## STP MSPI FAQ – Mixed Status Systems

## Millstone MSPI FAQs:

Figure 1

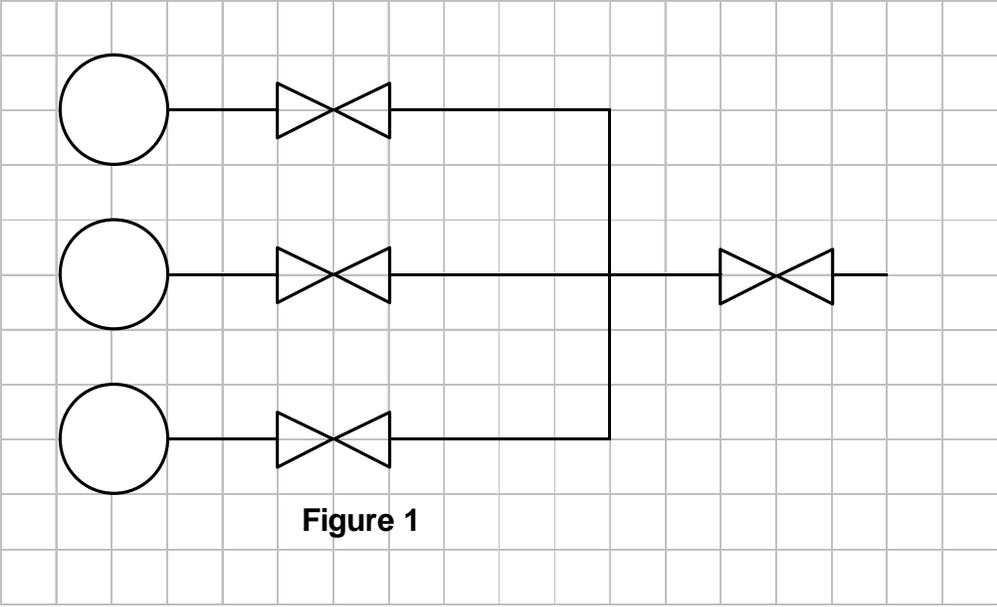
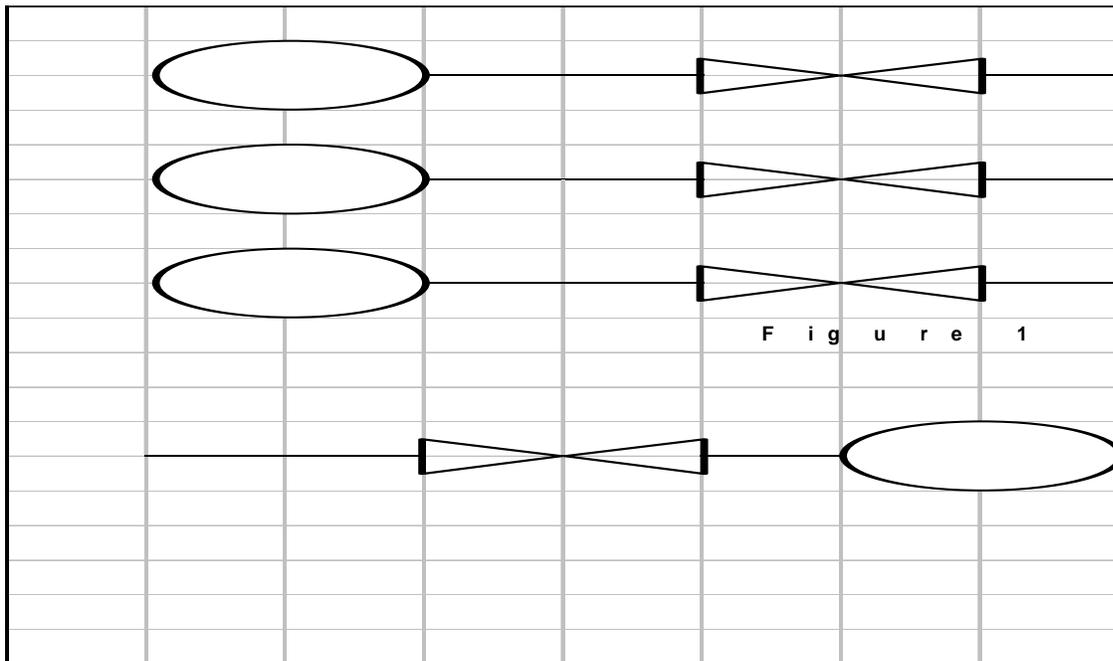
a) MP3 has three charging pumps. Each pump has one MOV on its recirculation line. There is an additional MOV on the common line (Figure 1). The three branch lines are power off one train and the common line is powered off the opposite train. Therefore for each pump either the common MOV or the branch line MOV must go closed. If the branch line MOVs and the common MOV do not close, all trains are lost. Would these valves be considered active?

The charging minimum recirculation valves would be counted as active valves since they do not meet the redundancy criteria in that a failure of all valves impacts both trains. The NRC staff concurs that this configuration is not a clear case of the straightforward parallel/series configuration discussed in Appendix F. However, it would appear that per the guideline in NEI 99-02, page 9, the fourth bullet, these valves need NOT be included as active components since no two combination of valve failures would fail all pumps.

Figure 3

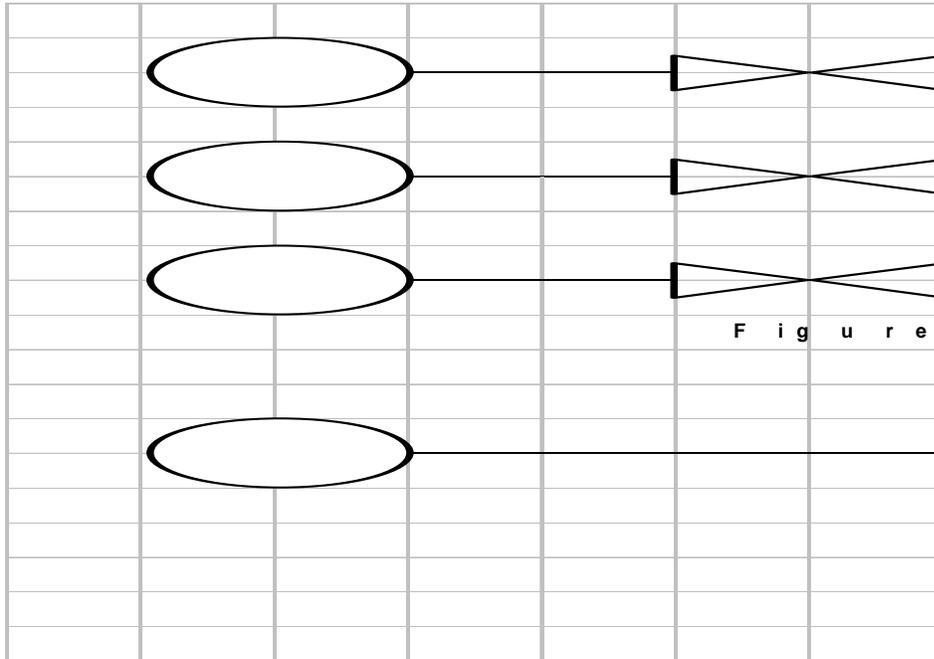
At MP3 there are two trains for hot leg injection. Each train has a MOV in its discharge line to the cold legs and there is also a MOV in the common line to the cold legs. During switchover to

hot leg injection, the discharge MOV to the cold legs is closed and the hot leg injection MOV is opened for one train and then the other train and then the common cold leg MOV is closed. To meet the hot leg injection requirements either the two discharge MOVs or the common cold leg MOV need to be closed. Would these valves be considered active?

Yes since if both the discharge MOVs or the common line MOV did not close both trains of hot leg injection would be lost. The success criteria as well as normal/accident valve positions for both the cold leg injection and the hot leg injection functions must be better articulated. NEI 99-02, page F-9 should be reviewed to identify if any two valve failures can fail the entire system function. If not, then the valves need not be included as active valves.
